TRIP REPORT

LOCATION: TERRY JONES PROPERTY, EMMETT IDAHO

TERRY JONES
CONSTRUCTION AND SITE PHOTOS

Berm that separates
the irrigation tail
water pond and the
irrigation canal water
(see next two pictures)

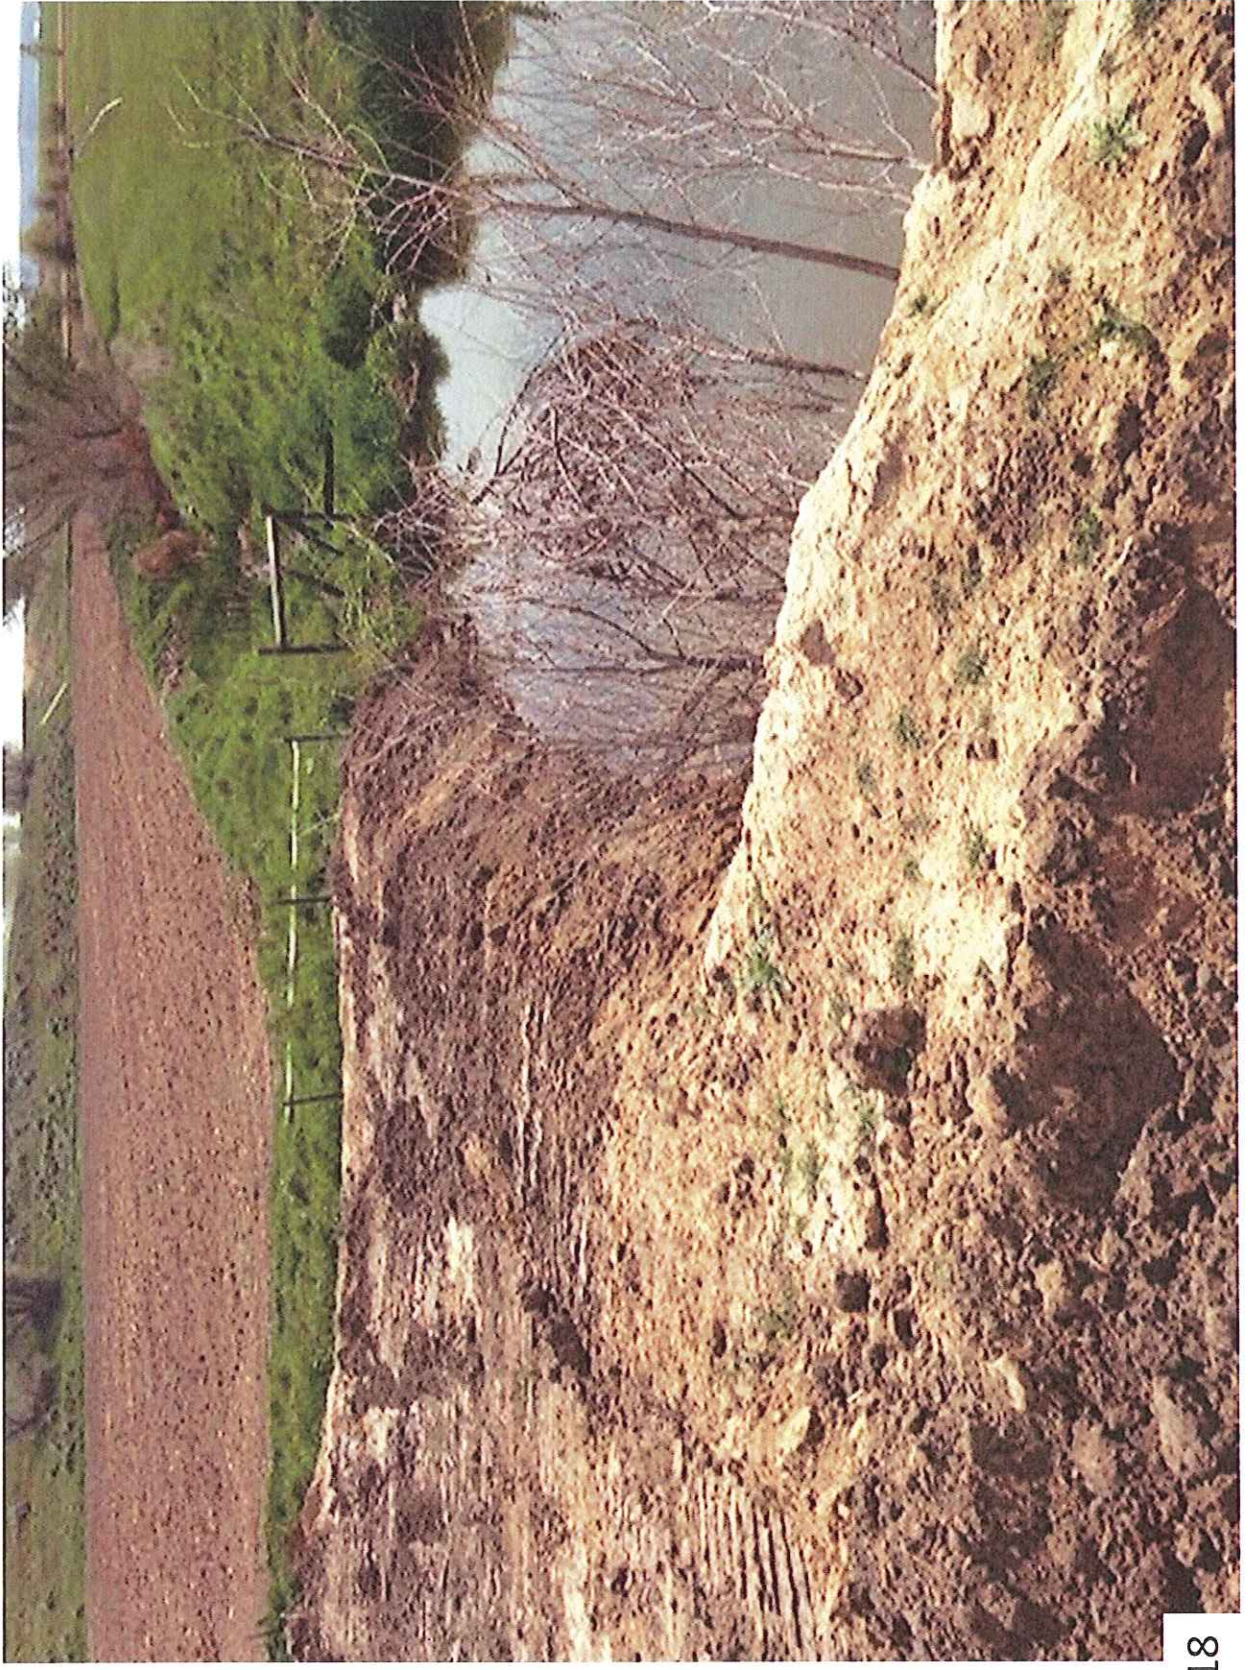
The berm between the irrigation tail water pond and the irrigation water (see pages 11 and 12 of the photos) is approximately 25 feet wide. Mr. Jones also stated that an impermeable liner was placed vertically in the berm to prevent water from the tail water pond leaching into the irrigation water. The top of the newly constructed berm is about 420 feet long and 14 to 18 feet wide. Measurements were taken using a measuring wheel. The north side of the berm slope is approximately a 3 to 1 slope with the south slope varying from a 1:1 to 2:1.

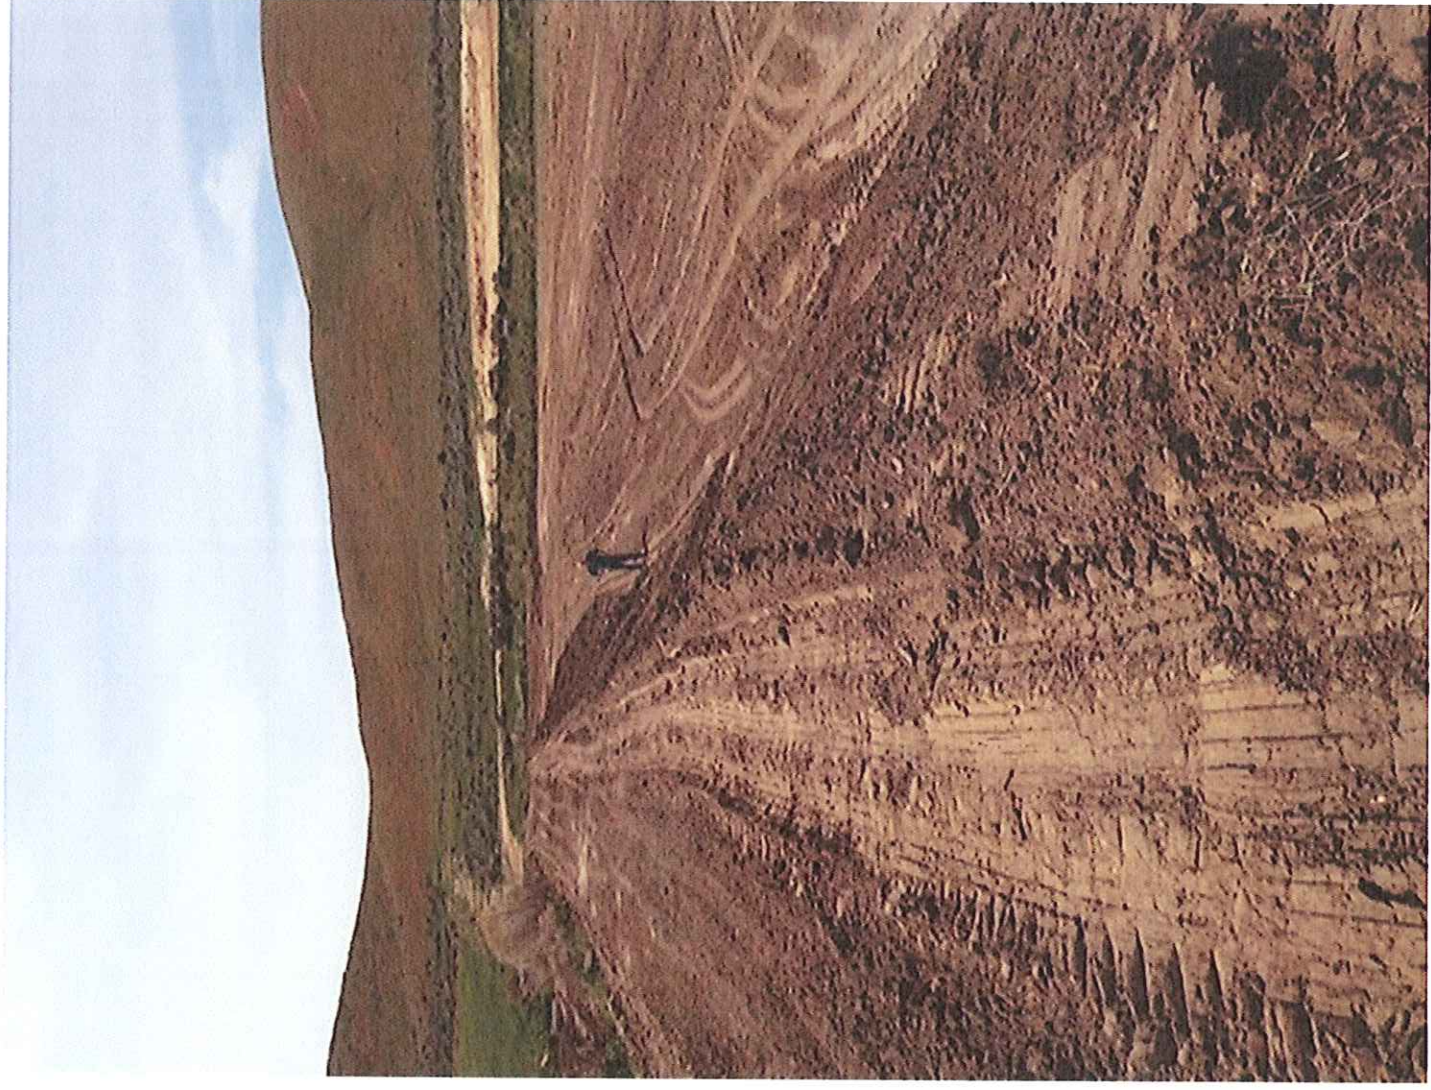
Note: 3 foot long
Soil
Penetrometer is
pushed all the
way into the
ground, noting
that compaction
is not adequate
to meet dairy
waste rules. If
this area will be
utilized in the
future for dairy
waste manure or
water storage,
the area would
need to be
compacted and
the soils would
have to be tested
to ensure it
would meet
IDAPA 02.04.14
Rules Governing
Dairy Waste
